Invincible Southern Extension Project

RESPONSE TO SUBMISSIONS
PART B

Response to Submissions – Part B

Prepared by
Umwelt (Australia) Pty Limited
on behalf of
Castlereagh Coal Pty Limited

FIGURE 1.1

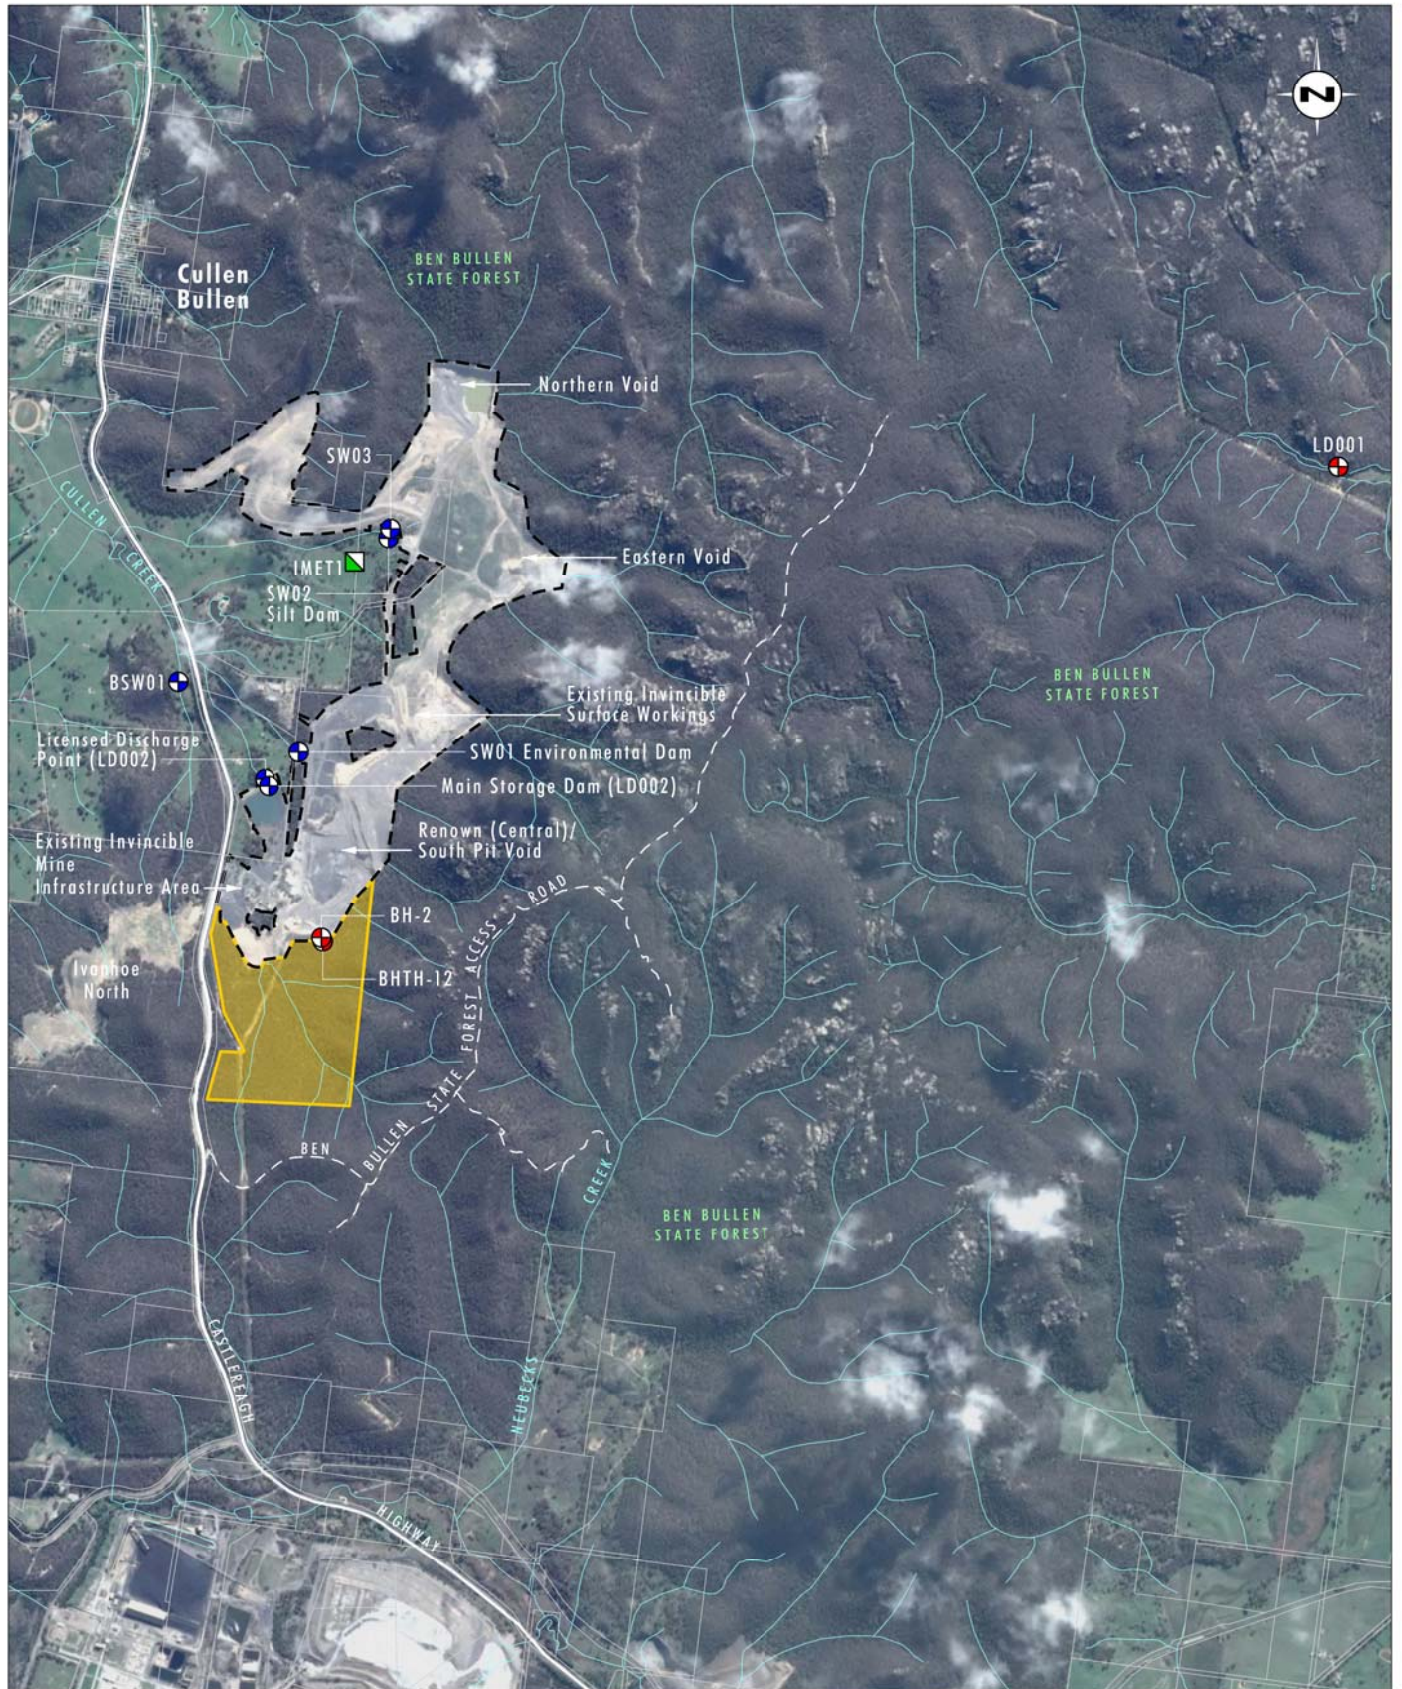
Clarify whether Cullen Creek is an upland river system, in accordance with the ANZECC guidelines.

Although Cullen Creek is located at elevations above 150 mAHD, water quality monitoring for Cullen Creek upstream of Invincible and in an adjacent catchment area (monitoring of EC undertaken by DPI-Water) indicates that the water quality in Cullen Creek is aligned to the default ANZECC guidelines for lowland river systems in NSW, not upland river systems.

Table 2.1 includes a comparison of the default ANZECC criteria for upland and lowland rivers and the 20th and 80th percentile surface water quality values resulting from analysis of monitoring points BSW01 (Cullen Creek upstream) and BSW02 (Cullen Creek downstream) (refer to **Figure 1.1**).

FIGURE 1.2

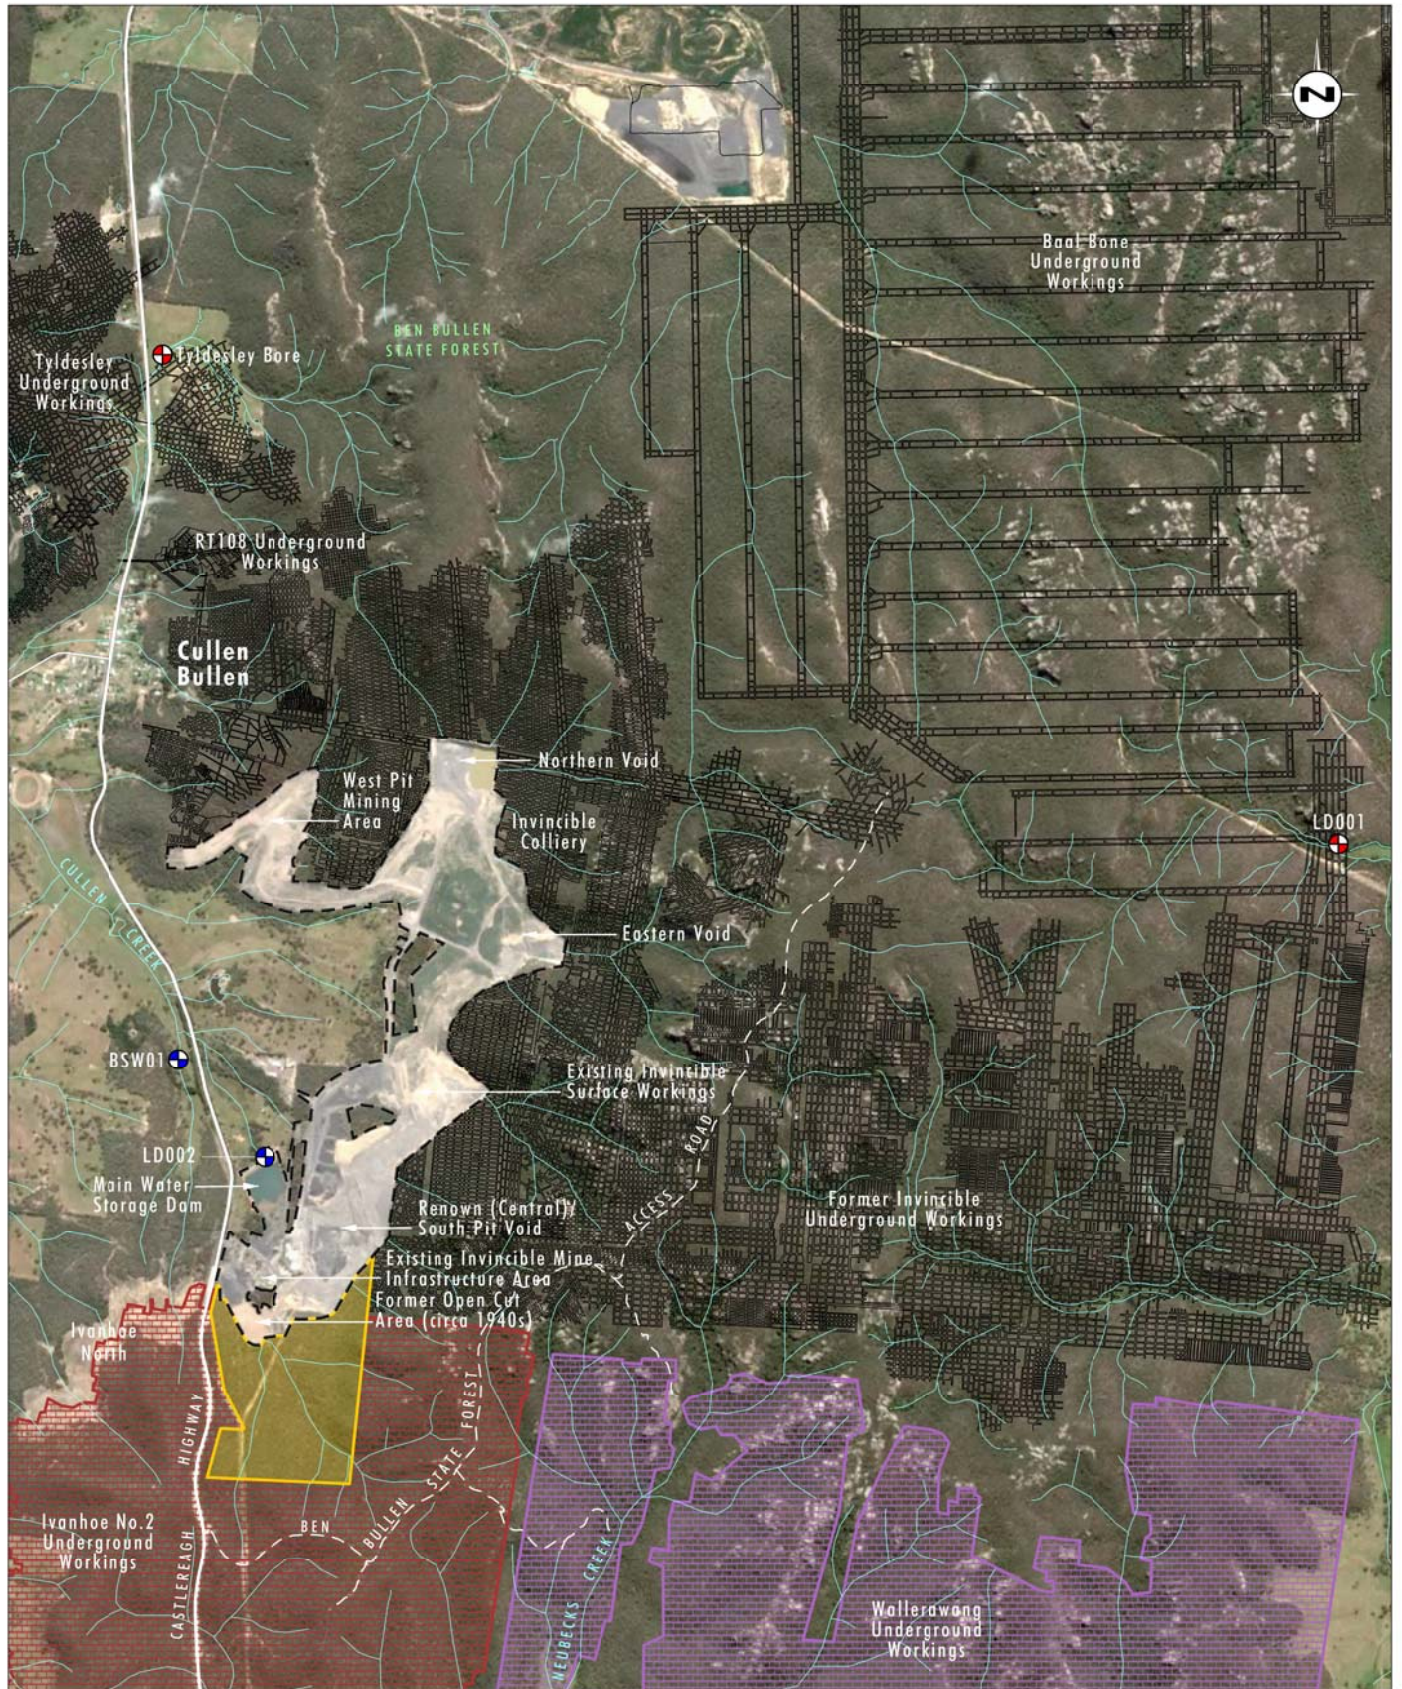
The proponent should clarify the potential impacts to Baal Bone Colliery operations due to the potential increase in seepage into their workings. The proponent should consult with the Baal Bone Colliery operators.

Appendix 1 includes an assessment of potential impacts on inflow rates to Baal Bone Colliery (refer to **Figure 1.2**) associated with the additional water stored in the Invincible Underground workings due to the proposed transfer of water from the Ivanhoe No. 2 Underground workings. This assessment indicates that it is likely the seepage rate will only increase by approximately 5%, to a rate in the order of 105 ML/year – 315 ML/year; which is an increase of 5 ML/year – 15 ML/year relative to existing conditions. Considering Baal Bone Colliery has been historically dewatered by Glencore at a rate of 1300 ML/year, this change in seepage from the former Invincible underground is considered to be minor.

FIGURE 1.3

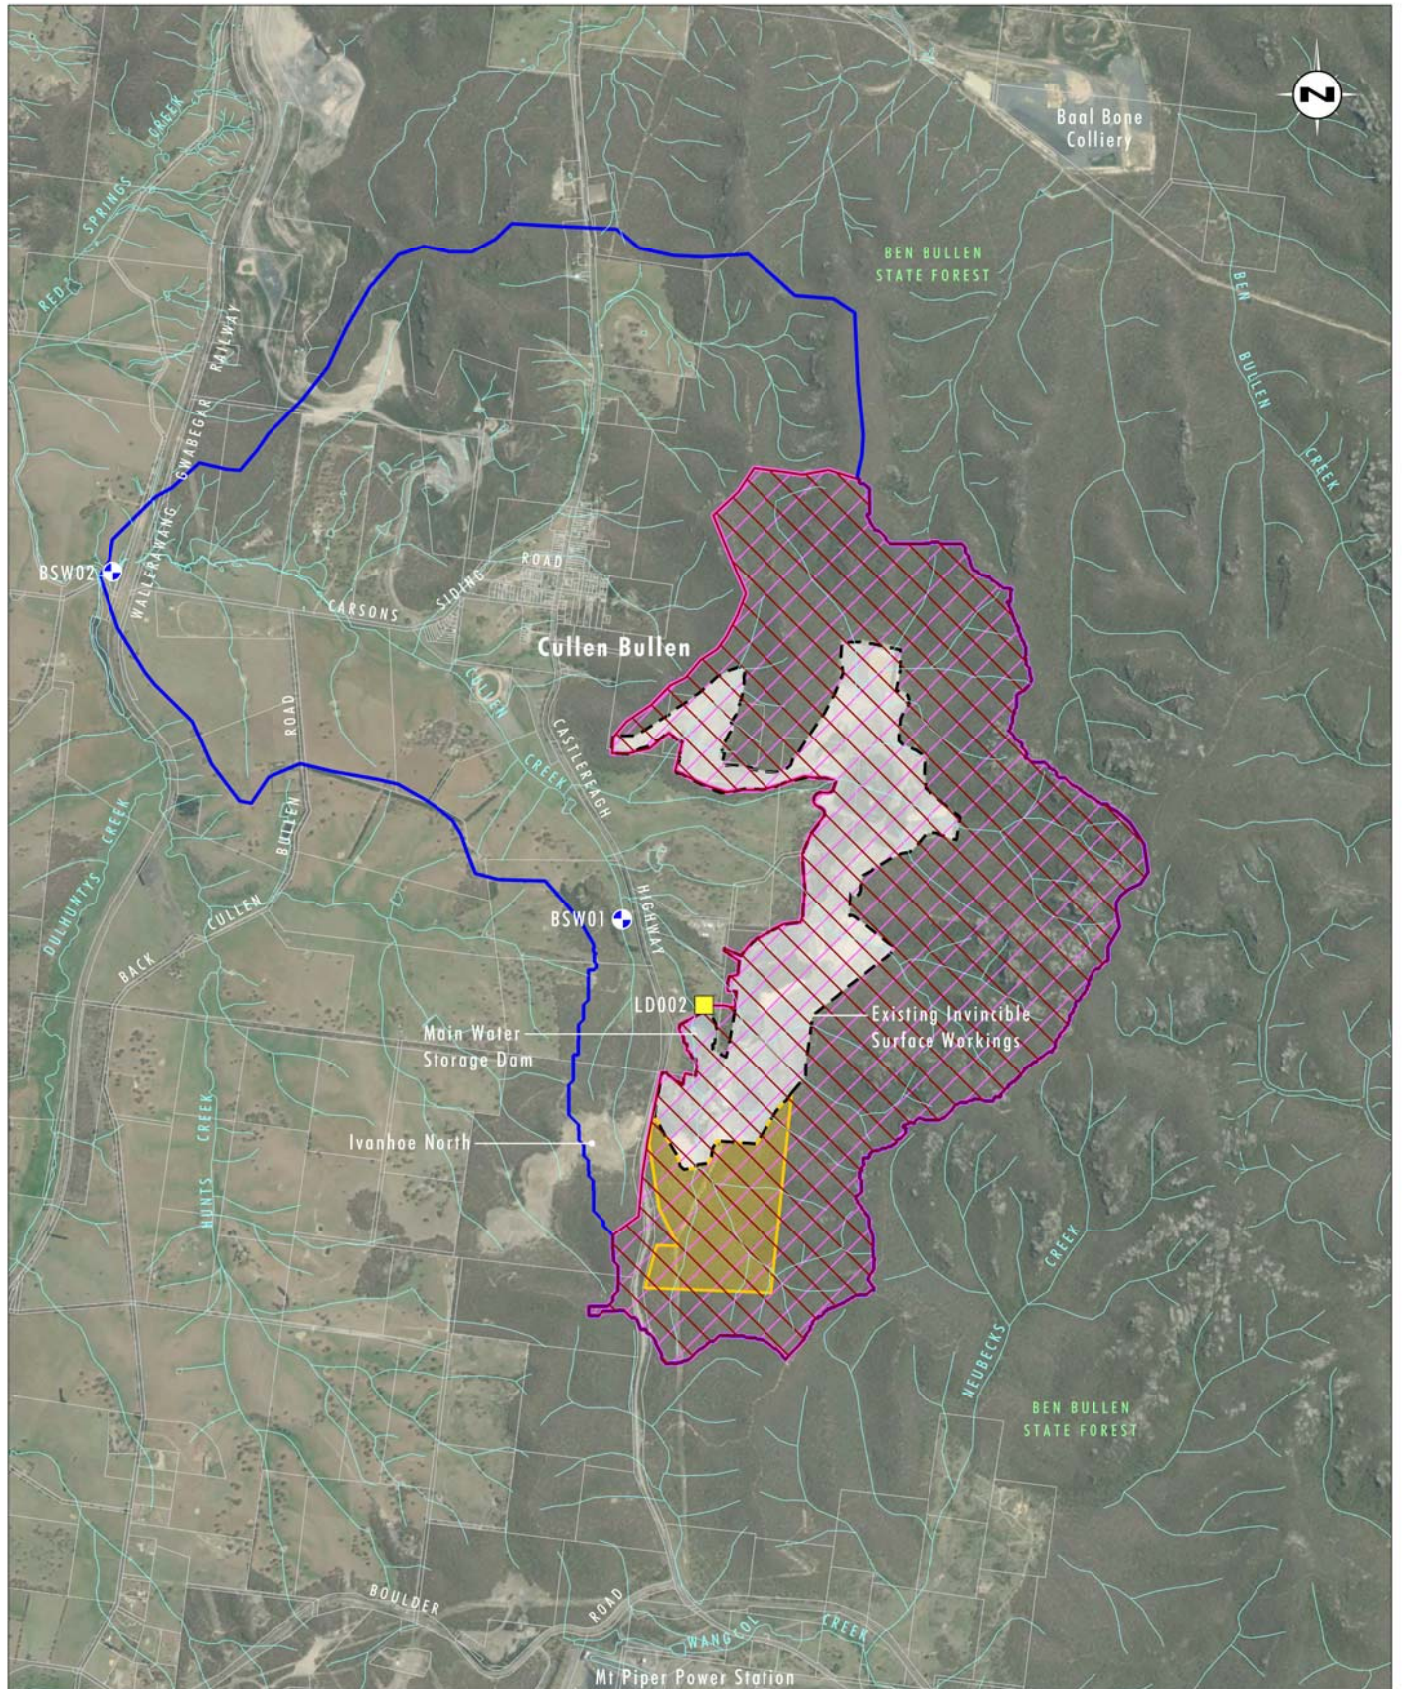
The actual details on the WMS for the operation of the Southern Extension Project are quite vague, especially where stage plans are presented as conceptual and statements suggest the WMS will be constructed and modified as and when required. It is therefore unclear what assumptions have actually been used in the Water Balance Assessment for the proposed expansion.

1. ***The stage plans presented are vague, conceptual in nature only and the WMS will be constructed and modified as and when required.***
2. ***Refinement of the design criteria and capacities are stated to be undertaken during detailed design stages of the Southern Extension Project***
3. ***Several years rehabilitation is necessary to be sufficiently established to be released to the environment***
4. ***Runoff from areas with existing rehabilitation will be released to the environment where runoff can be practically separated from runoff from mine and dirty water catchments (it is unclear what practically separated means in the current context).***

The Southern Extension Project will not increase the catchment area of the existing water management system (WMS). As can be seen from **Figure 1.3** (also included as Figure 6.4 in the EA) the WMS catchment area for the Southern Extension Project is the same as that of the currently approved operations (currently on 'care and maintenance'). The main difference between the two systems is the internal drainage system implemented to manage runoff from rehabilitated and newly disturbed areas proposed to be implemented as part of the Southern Extension Project.

Flooded workings - interpreted

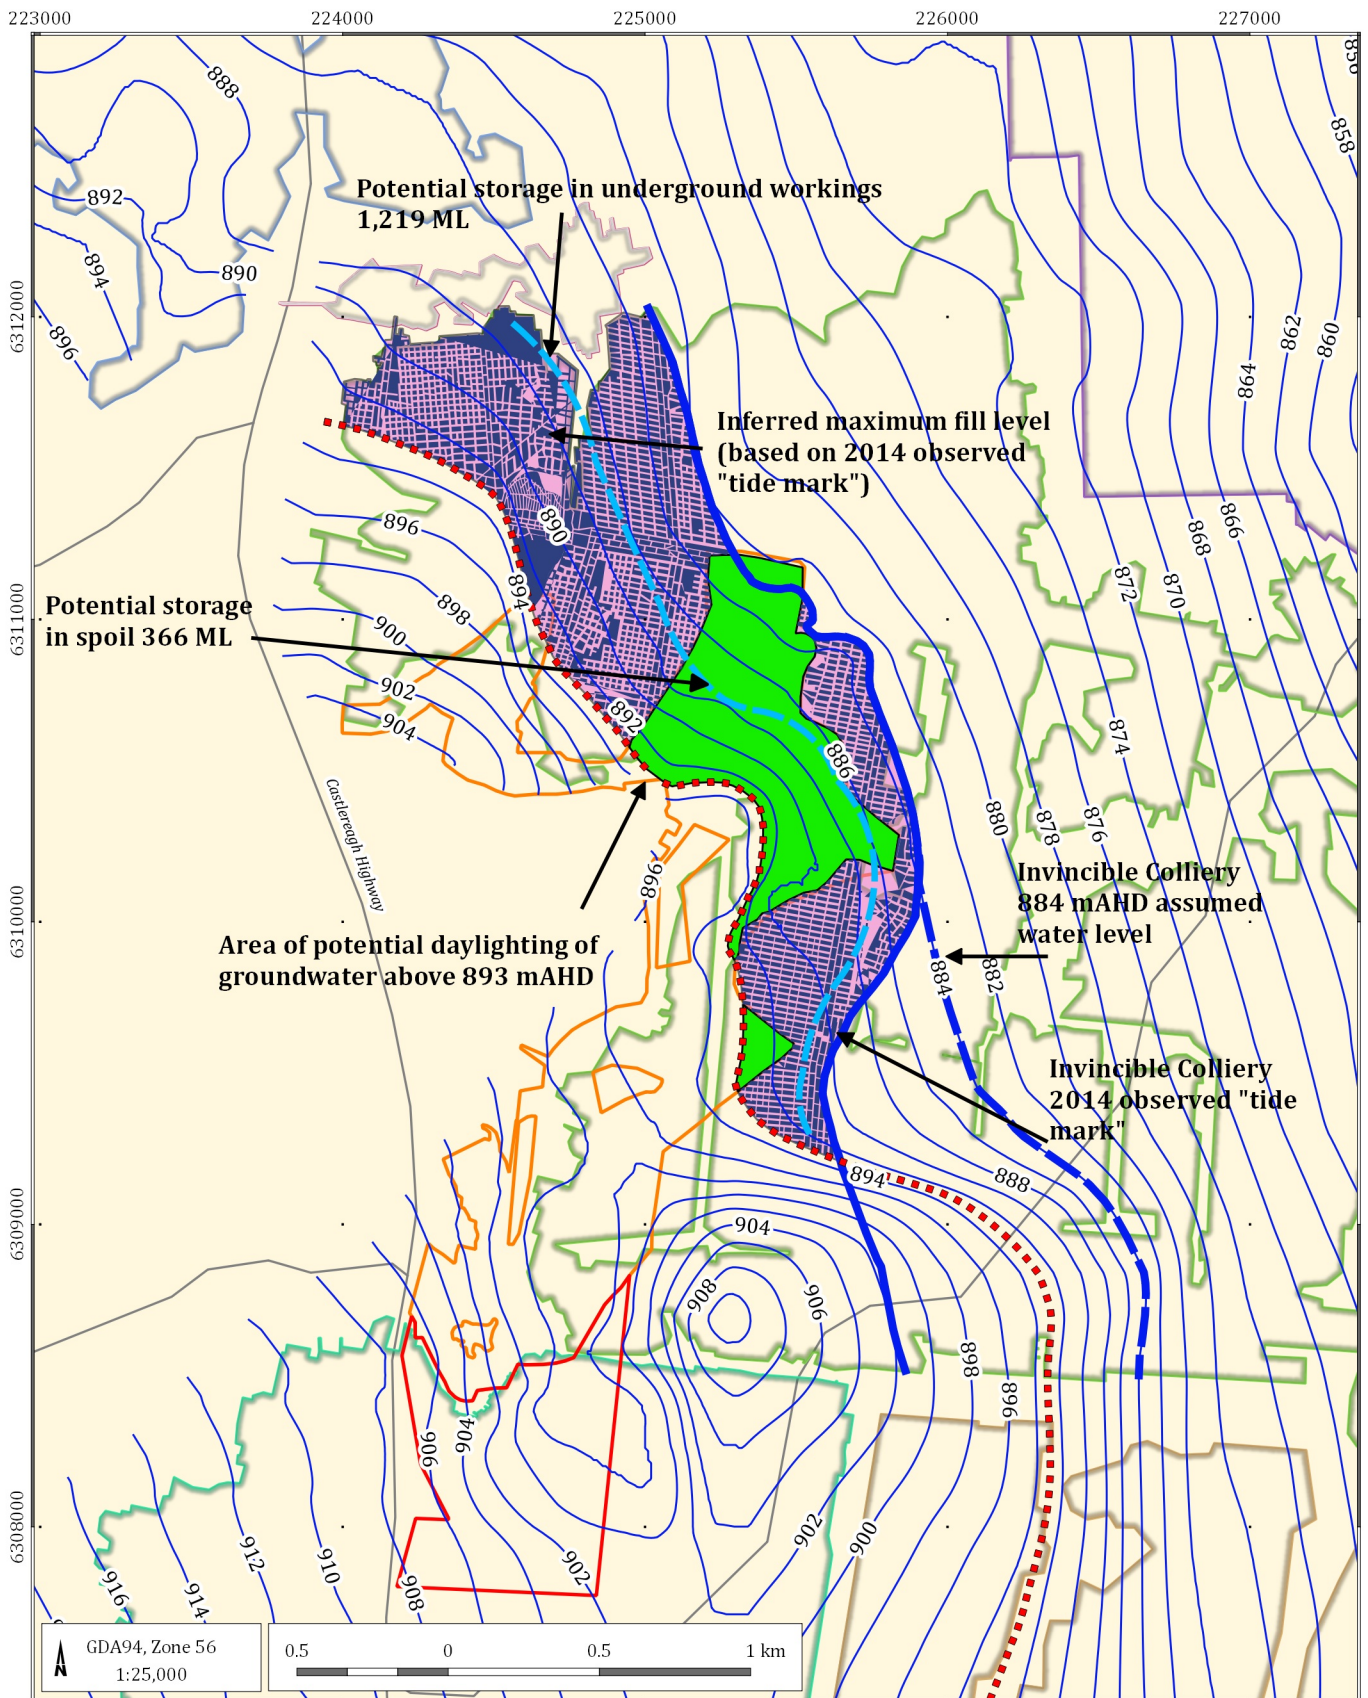
“The proponent should provide further detail of the water balance for the existing Ivanhoe No.2 accumulated water with respect to the 2,121 ML requiring dewatering. It is reported in the EA that the mine void is primarily made up of surface water flow through subsidence fractures, but this is calculated in the EA to be 7-20ML/yr which would total a potential maximum of 200 ML over a 10 year period”.

- The water level in the Ivanhoe No. 2 Colliery is constrained (refer Figure 2-1):
 - West – by the groundwater elevation within the Ivanhoe underground at BH12 (900.8 mAHD). A conservative value of 901 mAHD was used;

- If these assumptions hold true, and using the BH12 water level, the former Ivanhoe No 2 Colliery underground workings within the Southern Extension Project area is likely to hold 367,000 m³ (367 ML) (refer Figure 2-1). This volume is in the same order of magnitude as the calculated recharge over 10 years, that is 200 ML (AGE 2016).
